UNITED STATES PATENT AND TRADEMARK OFFICE

APPLICATION NO.	FILING DATE	FIRST NAMED INVENTOR	ATTORNEY DOCKET NO.	CONFIRMATION NO.
10/644,134	08/20/2003	Anton Gaile	298-209	5331
28249 7590 12/17/2007 DILWORTH & BARRESE, LLP 333 EARLE OVINGTON BLVD. SUITE 702 UNIONDALE, NY 11553			EXAMINER NGUYEN, XUAN LAN T	
			ART UNIT 3683	PAPER NUMBER
			MAIL DATE 12/17/2007	DELIVERY MODE PAPER

Office Action Summary

DETAILED ACTION

FIG. 6

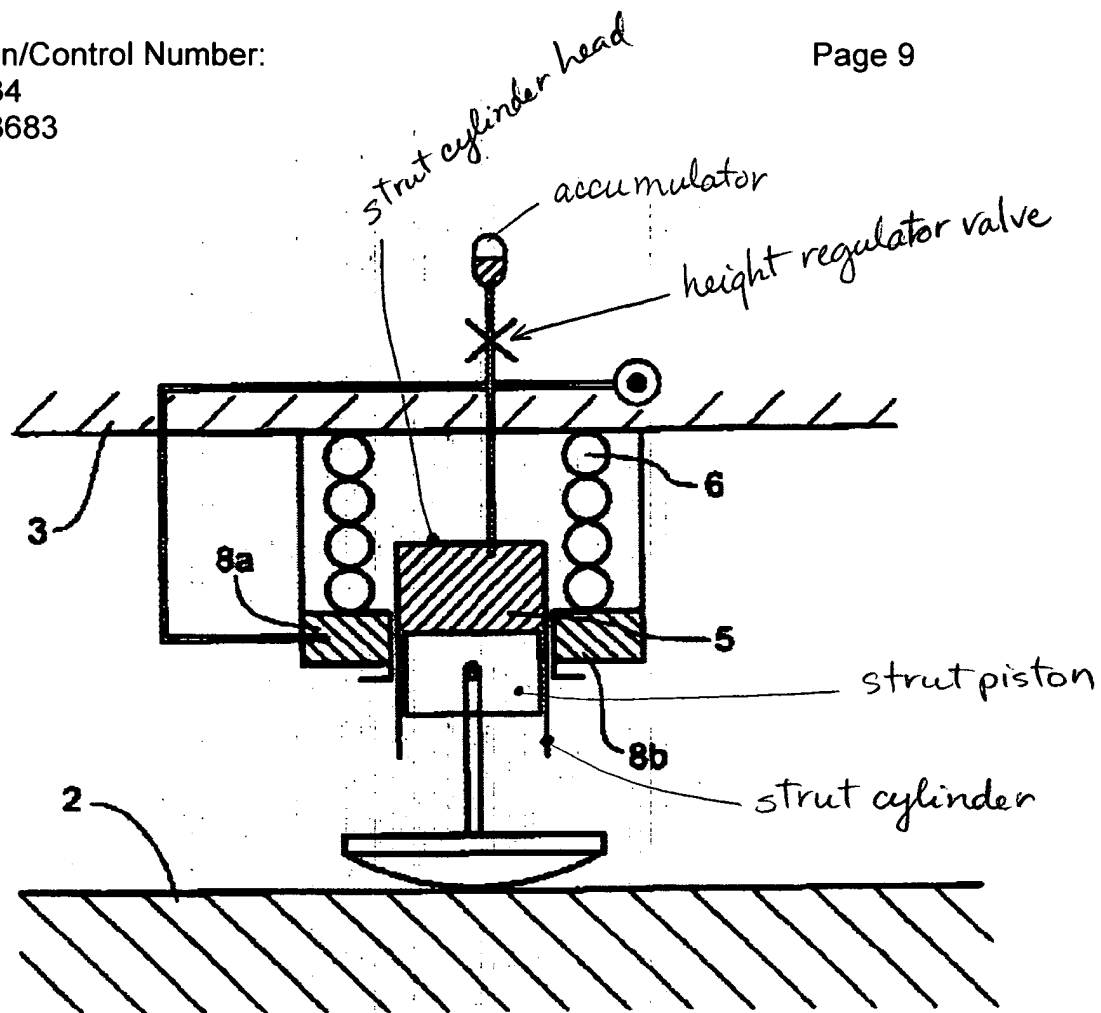
Re: claim 27, Teichmann shows a spring element in figure 6, as in the present invention, with a hydropneumatic strut to be positioned between a bogie 2 and a body 3 of a rail car, with the strut enclosing a sliding strut piston in a strut cylinder as marked below, whereby the strut piston or strut cylinder can be connected with the bogie and other of the strut piston and the strut cylinder can be connected with the body, and a cylinder piston space 5 is connected with a hydraulic accumulator as marked below, wherein the spring element comprises an auxiliary spring 6 which is concentrically arranged with the strut, encloses the strut cylinder, and is preloaded by a hydraulic cylinder 8b which is connected with the strut cylinder piston space 5.

Re: claims 1-3, Teichmann shows the hydropneumatic strut has a hydraulic height regulator valve as marked above connected with a feedback loop, by means of which the position of the piston in the cylinder can be adjusted or determined.

Re: claims 5 and 28, Teichmann shows a bore extending in a longitudinal direction of the cylinder is positioned in a cylinder head, and the mechanical feedback loop of the a height regulator valve is located in a bore extending perpendicular thereto in the cylinder head, as shown in the figure 6.

Re: claim 12, Teichmann shows a spring element in figure 6, as in the present invention, with a hydropneumatic strut to be positioned between a bogie 2 and a body 3 of a rail car, with the strut enclosing a sliding strut piston in a strut cylinder as marked above, whereby one of the strut piston or the strut cylinder can be connected with the bogie and the other of the strut piston and strut cylinder can be connected with the body, and a cylinder piston space 5 is connected with a hydraulic accumulator as marked above, wherein the hydropneumatic strut has a hydraulic height regulator valve as marked above, connected with a feedback loop, by means of which the position of the strut piston in the strut cylinder can be adjusted or determined, wherein the spring element includes an adjustment unit 8b, aligned with the strut, that can be height adjusted in the direction of movement of the strut and which is supported on the strut piston or strut cylinder, and wherein the adjustment unit includes a hydraulic cylinder piston 7b introduced into a hydraulic cylinder 7a, height-adjustable in the direction of movement of the strut, and supported on the strut piston or strut cylinder, as shown in figure 6.
